# Access Compliance Report

## Public Rights-of-Way

### (Curb Ramps)

Intersection ID: 21831	Main Street: ENGLAND_ST	Cross Street: WINDSOR_OAK_CT	Location: NW
ADA ID: ABD8A2283E80	Ramp Type: PerpDiag	Initial Pass/Fail: Fail	Overall Compliance: No
		Severity Score: 10

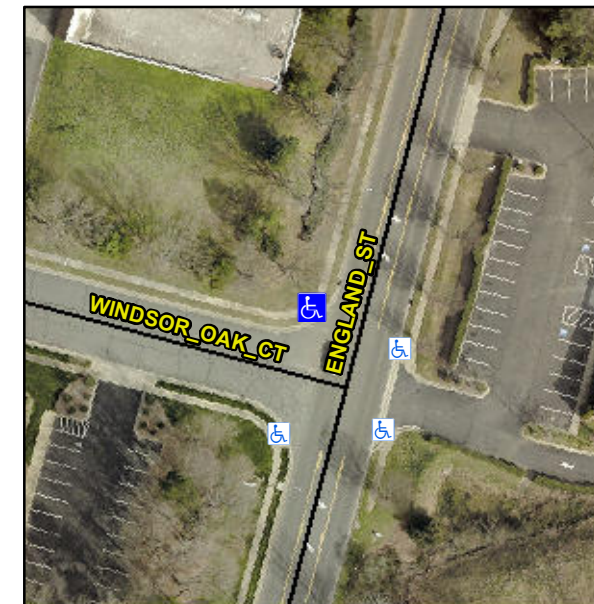
**R304.5.1, R304.5.3**

Compliance	Description	Data	Compliance	Description	Data
N/A	Ramp Length (in)	96.0	Yes	Ramp Slope (%)	7.1
No	Ramp Width (in)	44.0	No	Ramp XSlope (%)	3.7
N/A	Flare Type LT	N/A	N/A	Flare Type RT	N/A
N/A	Flare Slope LT (%)	N/A	N/A	Flare Slope RT (%)	N/A
N/A	Flare Traversable LT?	N/A	N/A	Flare Traversable RT?	N/A
N/A	Landing Length (in)	N/A	N/A	DWS Provided?	N/A
N/A	Landing Width (in)	N/A	N/A	DWS Contrast?	N/A
N/A	Landing Slope (%)	N/A	N/A	DWS Length (in)	N/A
N/A	Landing X Slope (%)	N/A	N/A	DWS Full Width?	N/A
N/A	Landing Curb? (Y/N)	N/A	N/A	DWS Offset (in)	N/A
N/A	Shared Landing?	N/A			
N/A	Gutter Ponding?	N/A	N/A	Gutter Slope (%)	N/A
N/A	Gutter Lip Ht (in)	N/A	N/A	Gutter X Slope (%)	N/A
N/A	Painted X Walk1?	No	N/A	Painted X Walk2?	No
	X Walk 1 Direction	To SW		X Walk 2 Direction	To SE
N/A	X Walk 1 Width (in)	N/A	N/A	X Walk 2 Width (in)	N/A
	X Walk 1 Slope (%)	2.8		X Walk 2 Slope (%)	0.6
	X Walk 1 X Slope (%)	0.2		X Walk 2 X Slope (%)	3.0

**Remove & Replace Curb Ramp With Two New Directional Ramps or Equivalent.**
